2002 Odyssey: PDI and New Model Information

This service bulletin contains information needed for PDI and describes the changes for 2002.

ENGINE

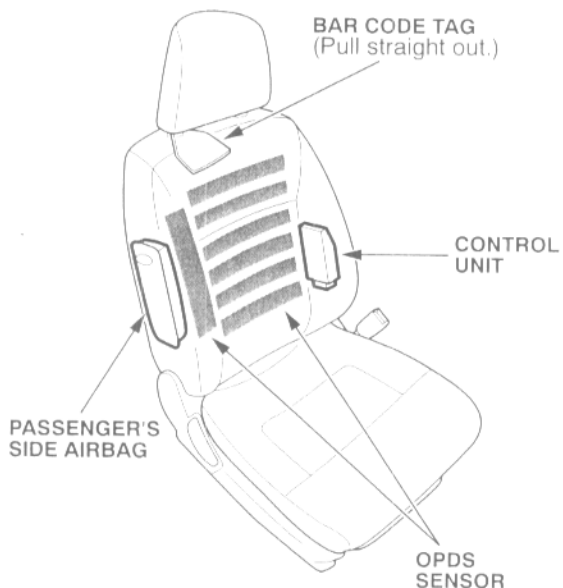
The intake, exhaust, and VTEC systems have been changed, and the compression ratio has been raised to 10.0:1. The horsepower rating is now 240 HP. Regular unleaded fuel is recommended.
